K350-1-DSSP-SUP

December 2011

U-Joints for Passenger Cars & Trucks

Changes from original:

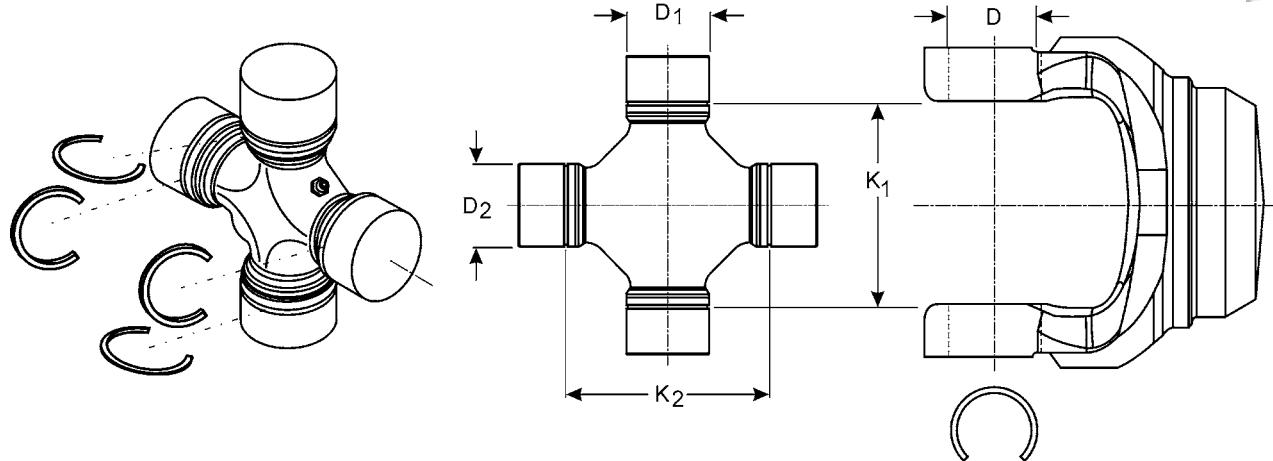
Page 52, K1 and K2 "Between Snap Ring" Dimensions for OE Mfg. Spicer, OE Series SPL30 changed from 2.288 to 2.409

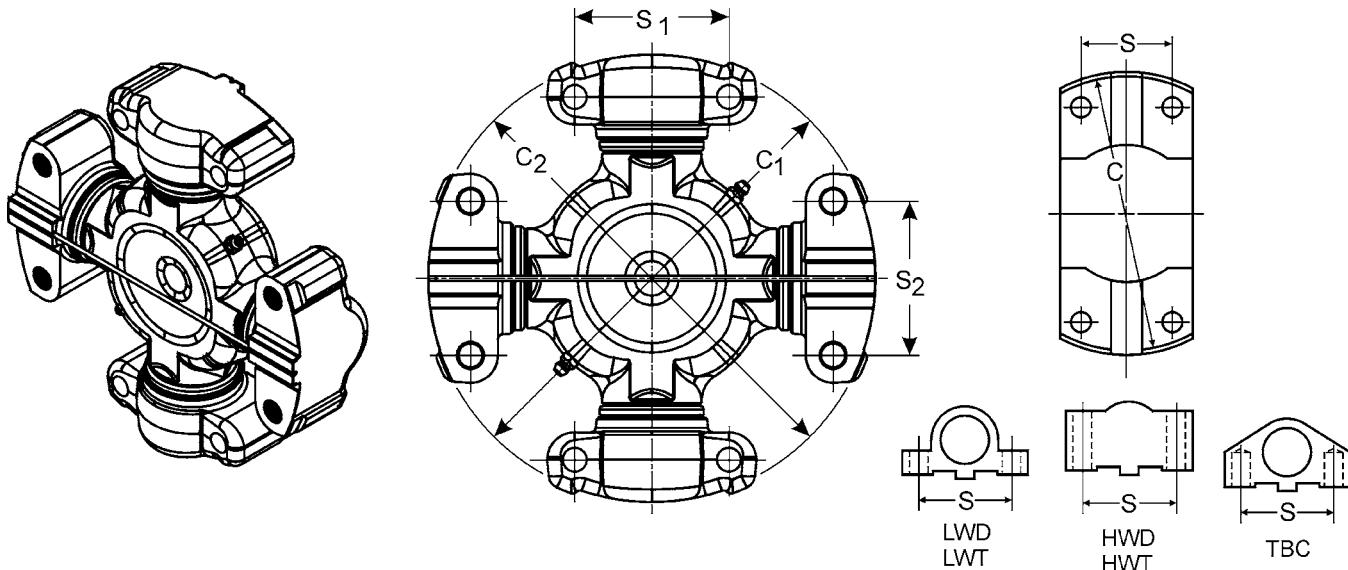
Page 58, Part# 5-2002X, S2 = 1.312

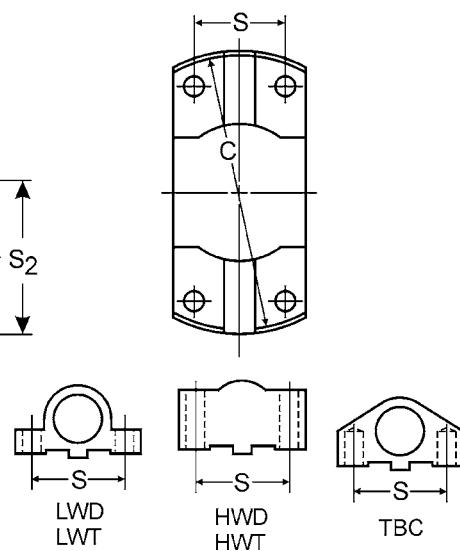
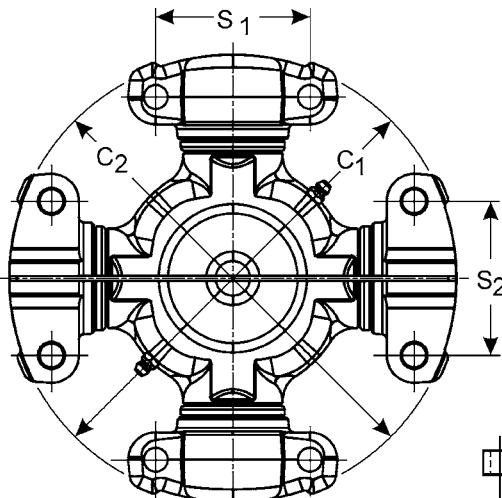
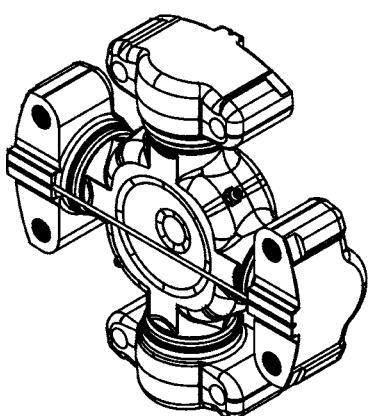
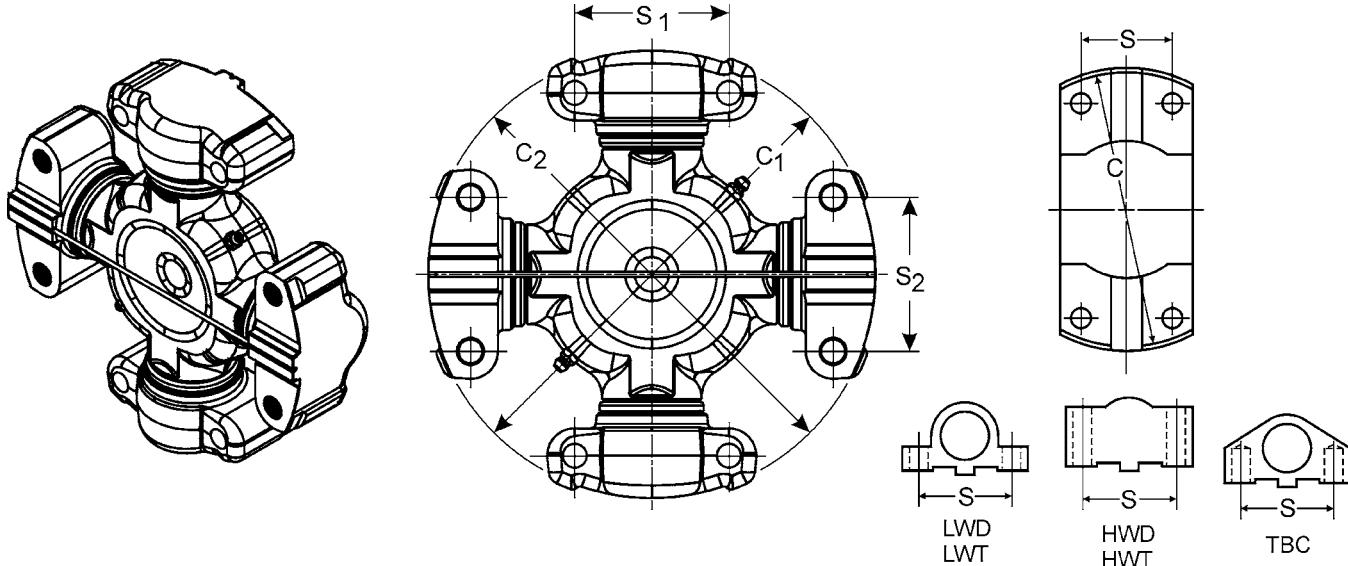
Pages 59-60, Corrected bolt part numbers in multiple notes; corrected centerline to centerline dimension for 050A89000.
